Change Order Request

Williamson County Expo Center
210 Carlos G. Parker Blvd, NW

Change Order Request: 004

Owner Change Order 004 - Incorporates Alternates #1 & #3 & additional scopes requested by Williamson County. Due to the schedule impacts of Alternate #1 Covered Penning. Flintco is requesting 78 calendar days which moves the contractual substantial completion from June 21, 2016 to September 7th, 2016.

E1-0

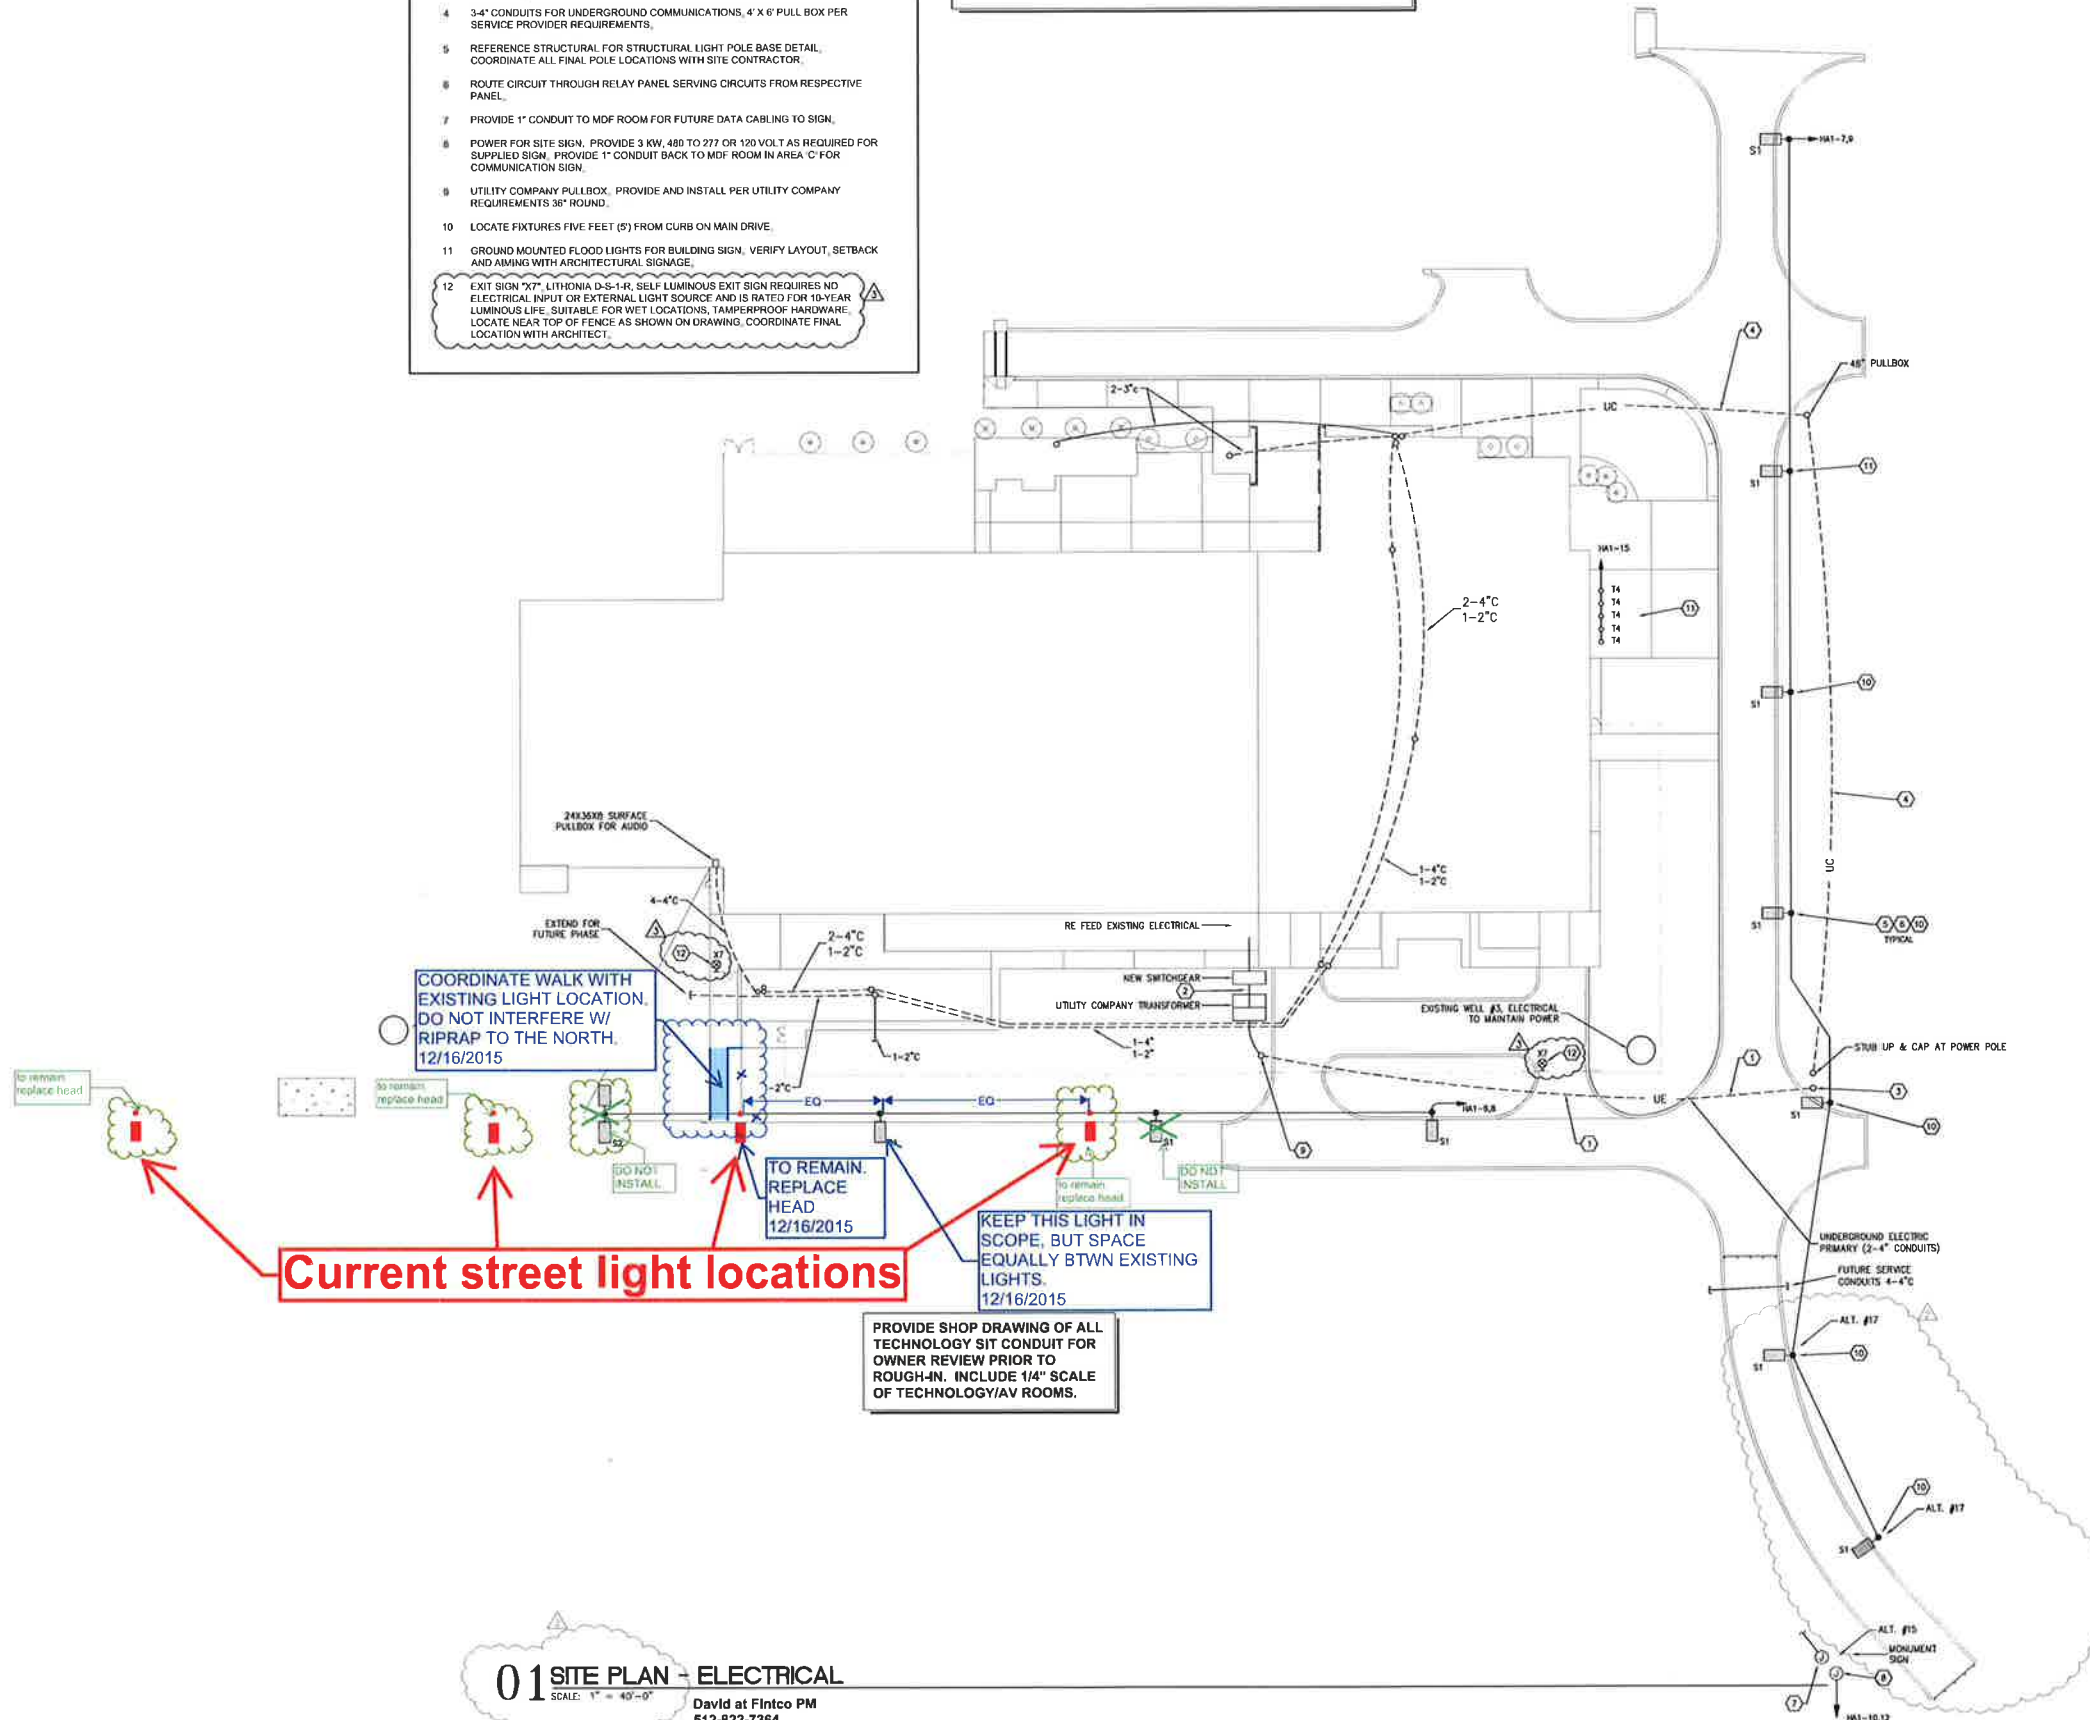
Question Date Required: 12/10/2015
Reference E1-0

E1-0 indicates new light poles at locations indicated in black. Existing light approximate locations are indicated in red.
Demo plans do not call for any of these existing lights to be removed. Please provide direction on what existing lights are
to remain and what new lights are to be installed.

Contractors Suggestion is acceptable
to the engineer. Since the quantity of
fixture heads would be equal. Replace
heads on existing poles to match new
pole fixture light. Provide appropriate
credit for pole and pole base.

See attached mark-ups for revised direction,
based on OAC Meeting.

PROVIDE ALTERNATE PRICE TO REPLACE EXISTING POLE LIGHT FIXTURE HEAD WITH AUTOBAHN SERIES ATBMH 480 R4. FIELD VERIFY QUANTITY.

PROPANE TANK EXHIBIT

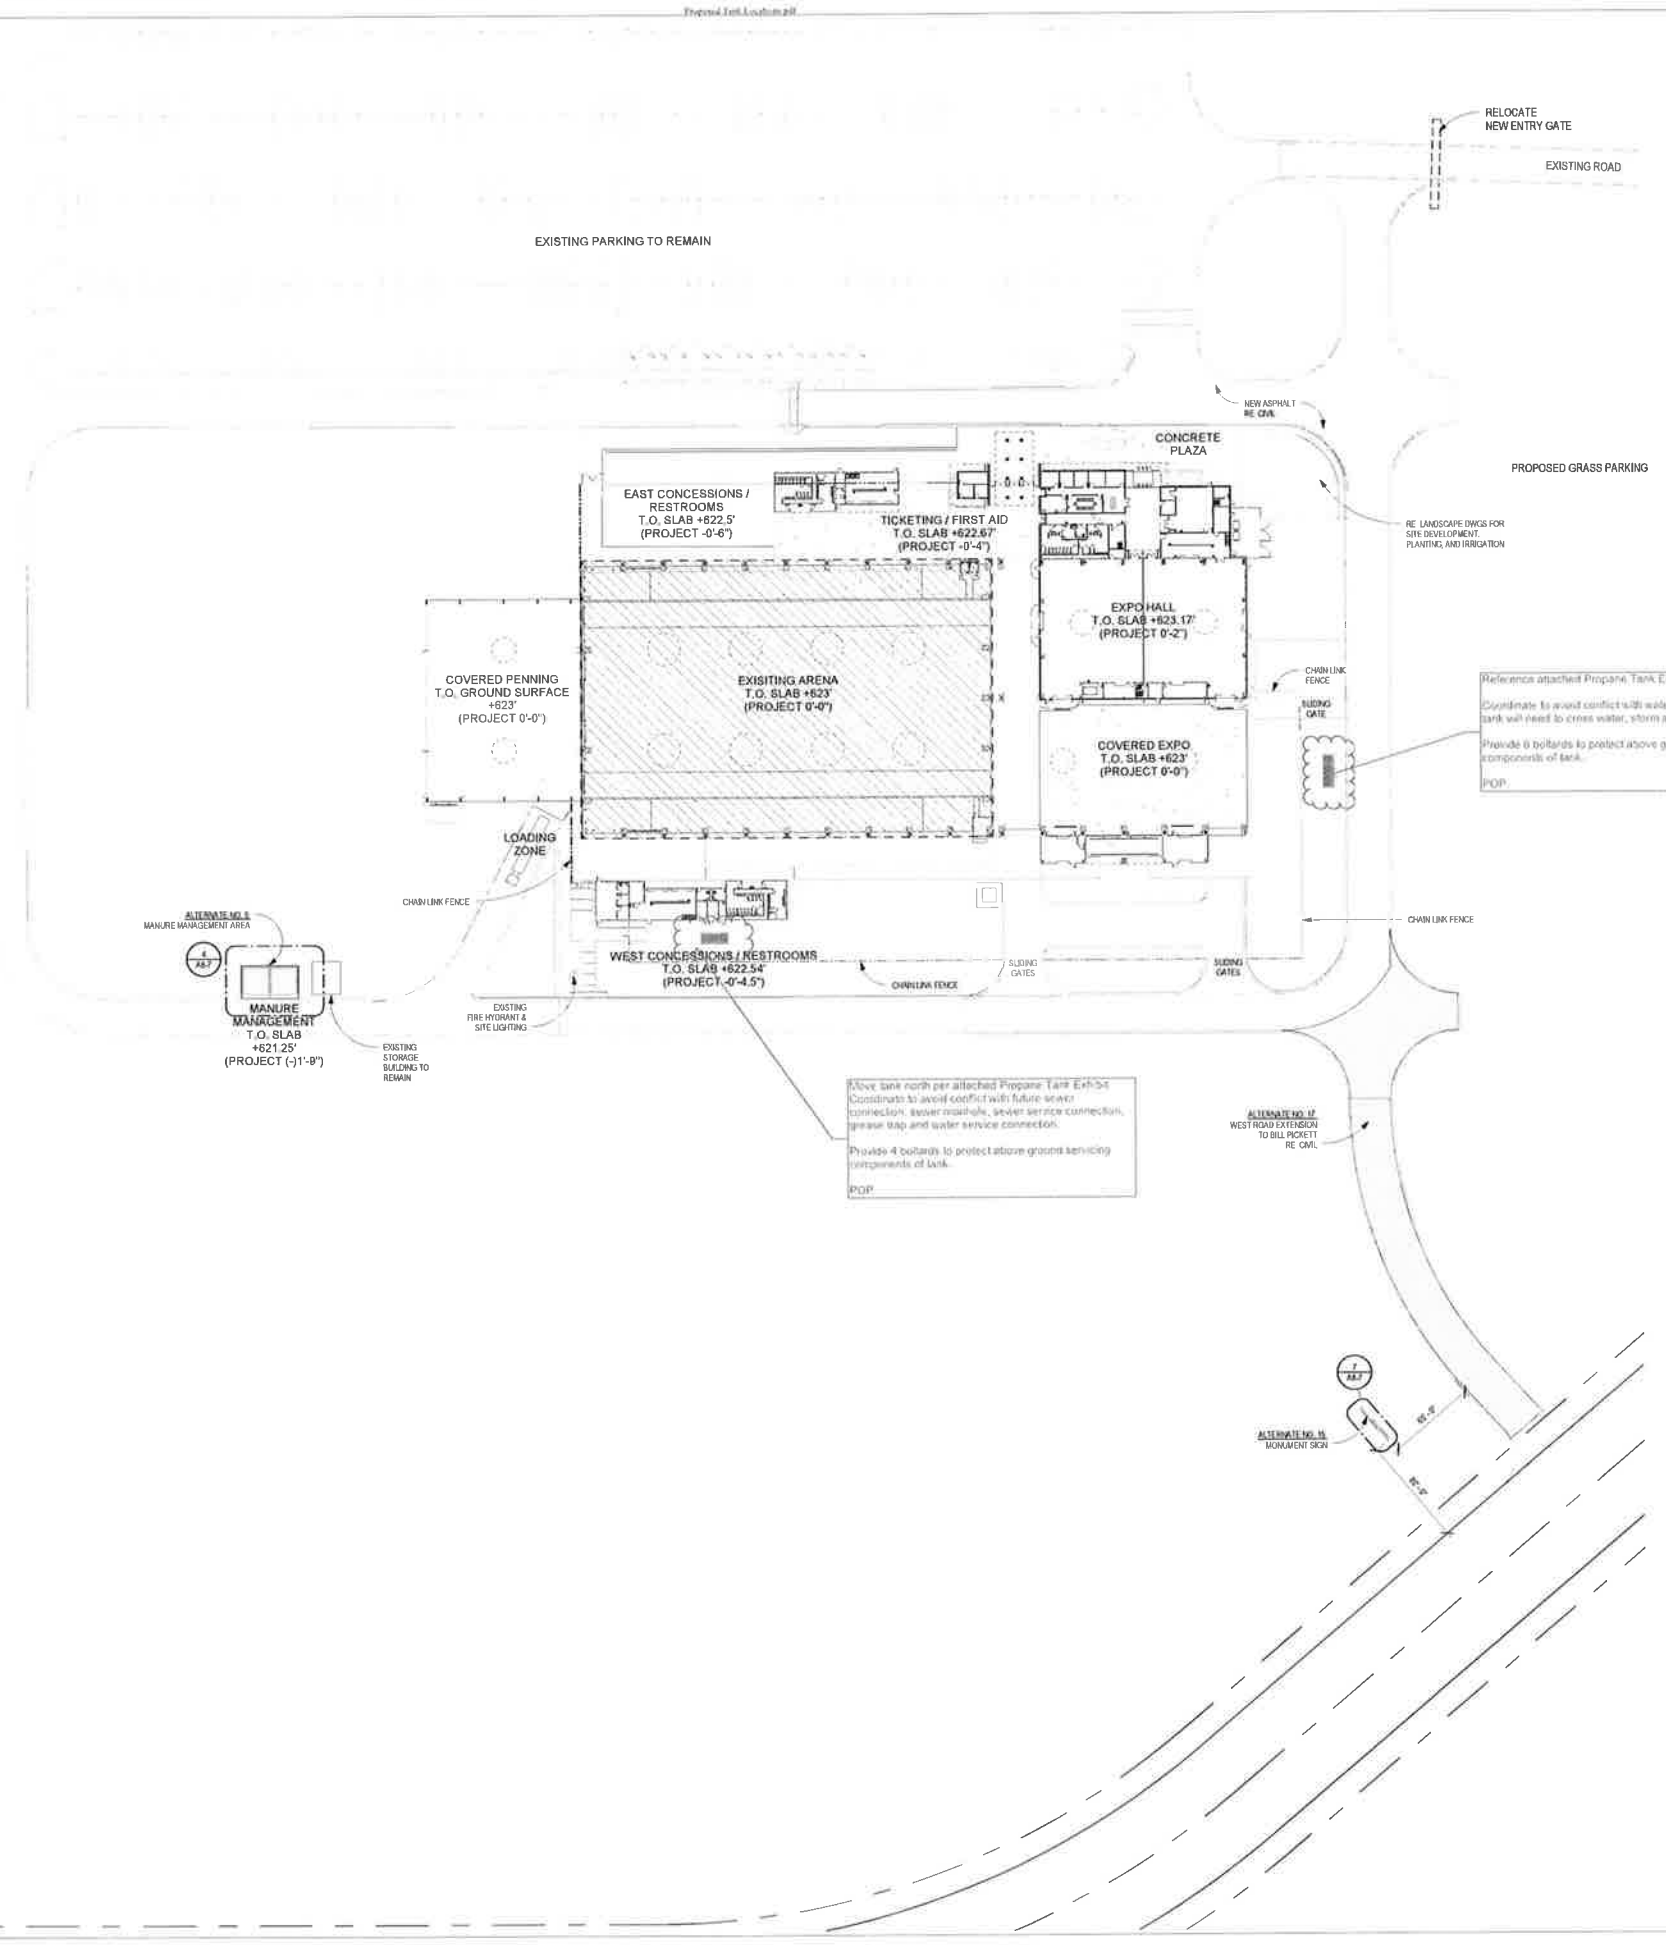
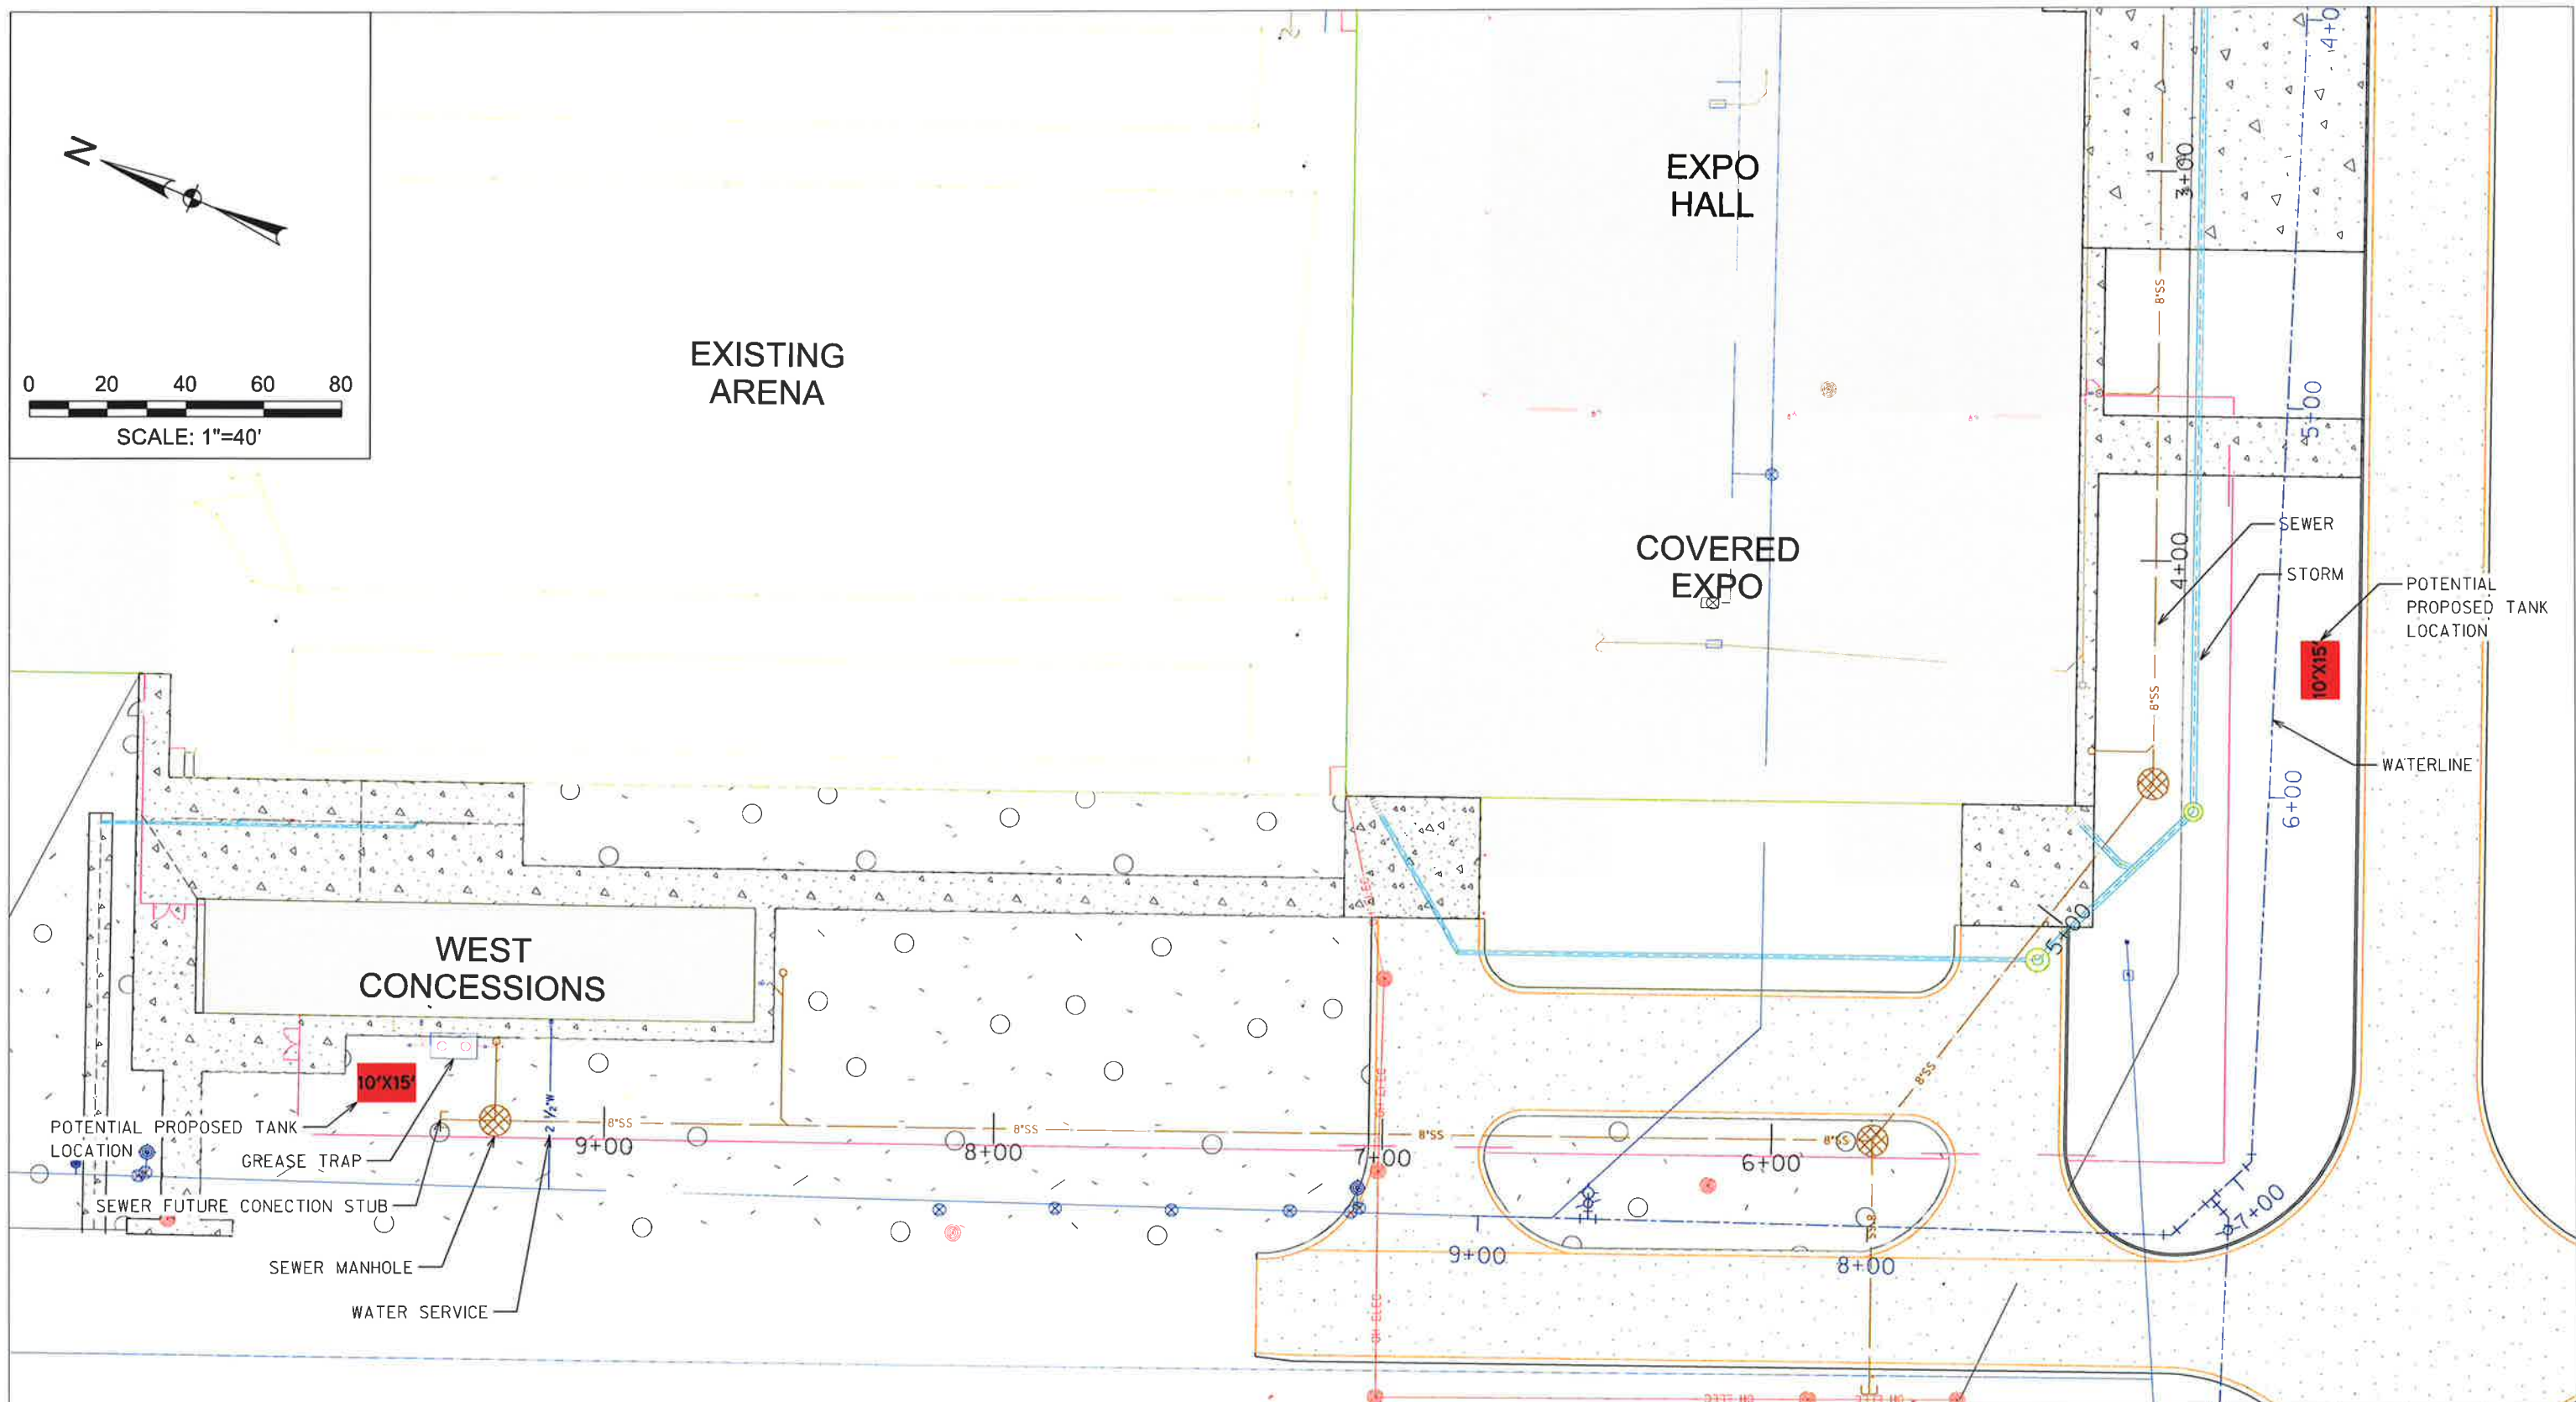
It was discussed onsite to locate the propane tanks as indicated on the attached drawing. Please confirm location of tanks as well as all necessary protective measures around the areas. Also, please provide all required piping and routing to accommodate tank locations.

Reference attached Propane Tank Exhibit for recommended locations and coordination notes.

Need 10 bollards to protect both tanks.

- NOTES:
1. EXACT TANK LOCATIONS BY OTHERS.
 2. UNKNOWN TANK DIMENSIONS. (10'x15' SHOWN FOR REFERENCE)
 3. PROPOSED TANK WEST OF WEST CONCESSIONS MUST AVOID CONFLICT WITH FUTURE SEWER CONNECTION, SEWER MANHOLE, SEWER SERVICE CONNECTION, GREASE TRAP AND WATER SERVICE CONNECTION.
 4. PROPOSED TANK SOUTH OF COVERED EXPO NEEDS TO AVOID CONFLICT WITH WATER MAIN. PLUMBING TO TANK WILL NEED TO CROSS WATER, STORM AND SEWER MAINS.
